**STAFF RECOMMENDATION**

**330 Chesterfield Avenue**

**September 16, 2020**

**Application:** New Construction – Porch Roof Extension  
**District:** Hillsboro-West End Neighborhood Conservation Zoning Overlay  
**Council District:** 18  
**Base Zoning:** RS7.5  
**Map and Parcel Number:** 104100080.00  
**Applicant:** Meredith Sacks  
**Project Lead:** Jenny Warren, jenny.warren@nashville.gov

Figure 3: Proposed porch roof expansion

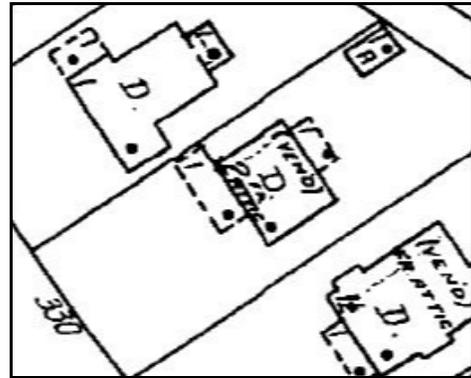
Location & Removability: Generally, an addition should be located at the rear of the building in a way that will not disturb the front façade. The proposed extension of the porch roof along the front elevation is not appropriate as it will alter the original design of the front of the historic building.

Roof form: The roof of the proposed porch extension would match the existing shed roof in form and pitch. However, extending the roofline to cover a portion of the front elevation, which was historically uncovered, alters the historic porch roof form in an inappropriate manner.

The project does not meet section II.B.1.e.

Staff recommends disapproval of the porch extension, finding that the project does not meet Section II.B.2 of the *Hillsboro-West End Neighborhood Conservation District: Handbook and Design Guidelines*.
